Project: Twin Hills Power System Upgrade

Solicitation No.: 19023

Addendum No. One

GENERAL – QUESTIONS & ANSWERS

2 BUILDING SECTION
M3.1 3/4"=1'-0"

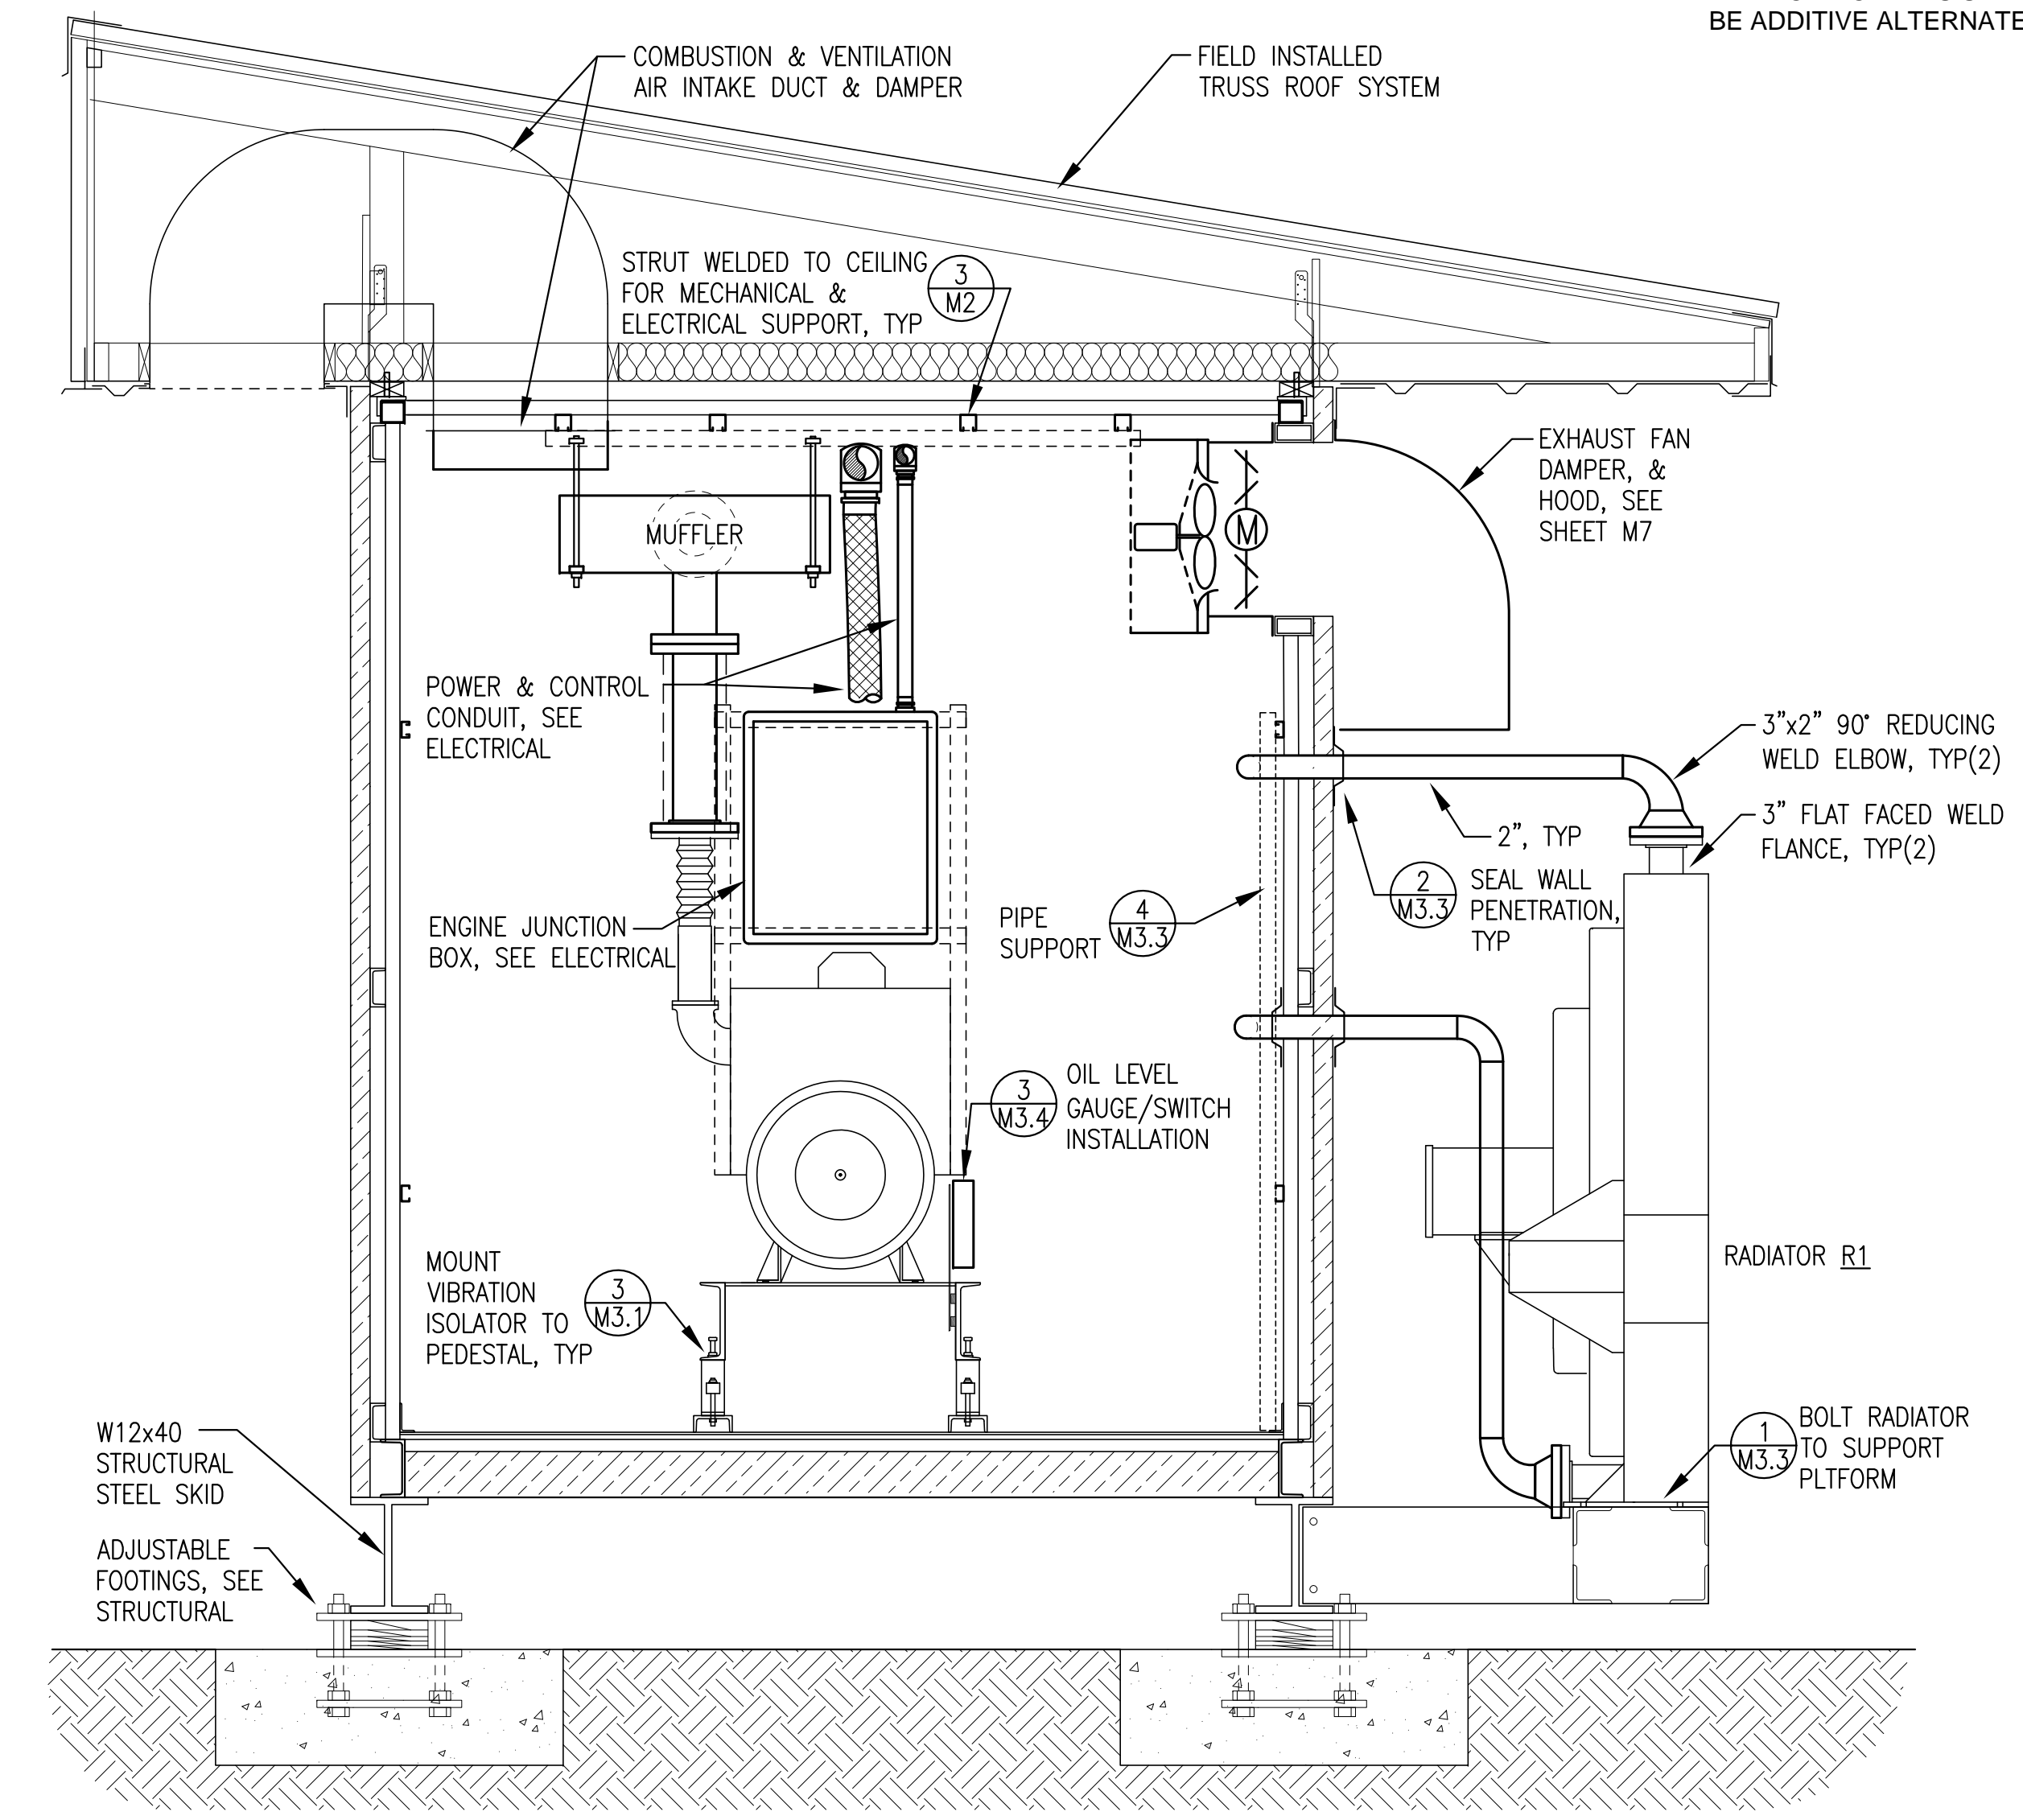
12) **Q:** Discrepancy in drawing S1 & M3.1 for the radiator support; S1 detail 1 indicates a concrete foundation and M3.1 displays a mod mounted foundation. Is S1 incorrect?

A: The radiator support from the skid shown on Sheets M2.2 and M3.1 is correct. Delete the radiator support concrete pad shown on sheet S1.
